# Service Bulletin

Bulletin No.: 17-NA-304

**Subject: Ticking, Rattle and/or Buzzing Noise Heard from inside Passenger Compartment, Possible Fuel Leak**

4870639

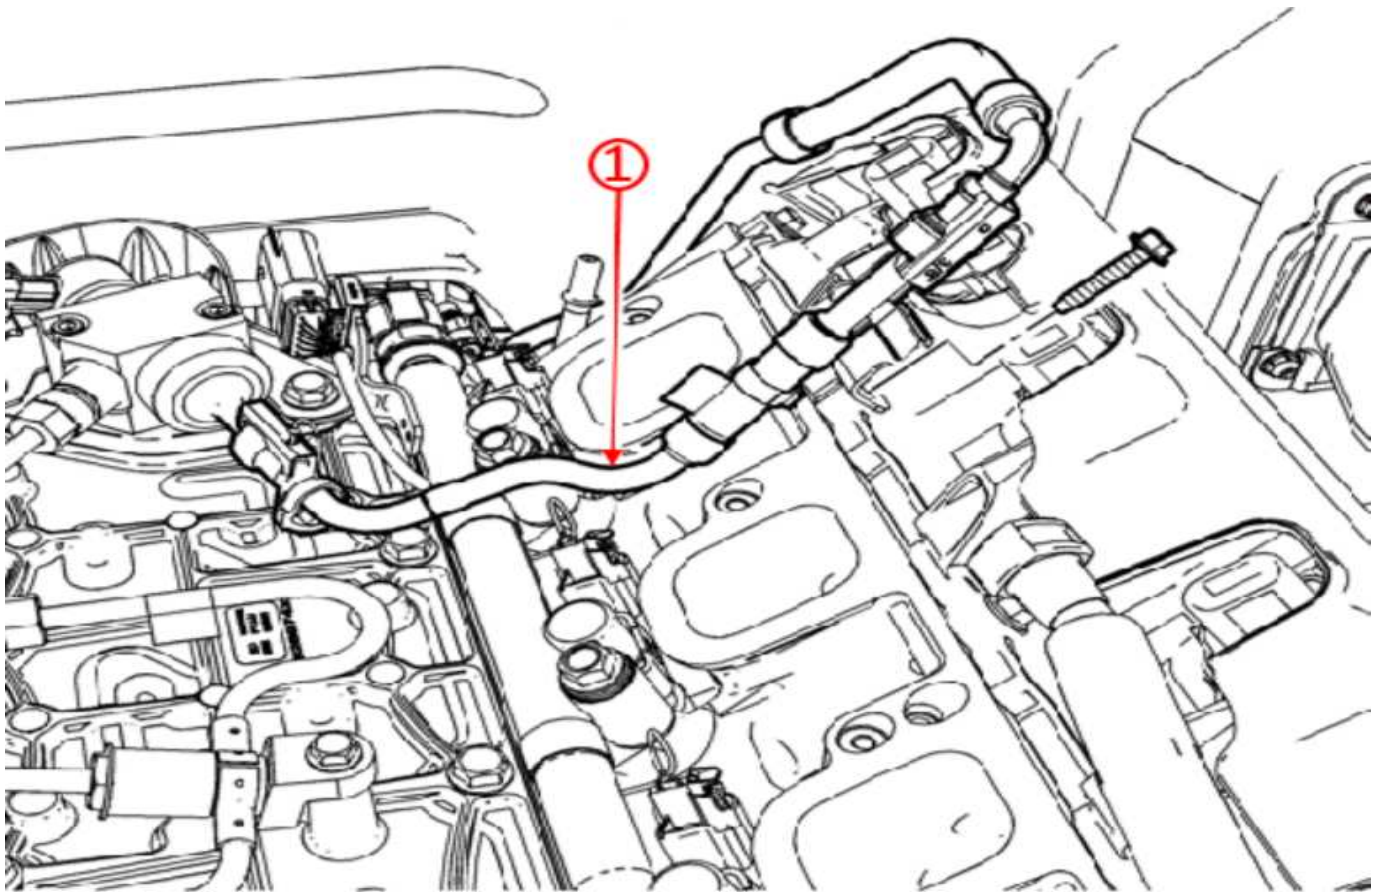
**Low pressure fuel feed jumper pipe at engine**

**Original design fuel feed line at tank**

**Updated design fuel feed line at tank**

Install a new low pressure fuel feed jumper line at the engine, and replace the original design fuel feed line at the tank with the appropriate updated design PN listed in the Parts table, following the procedure below.
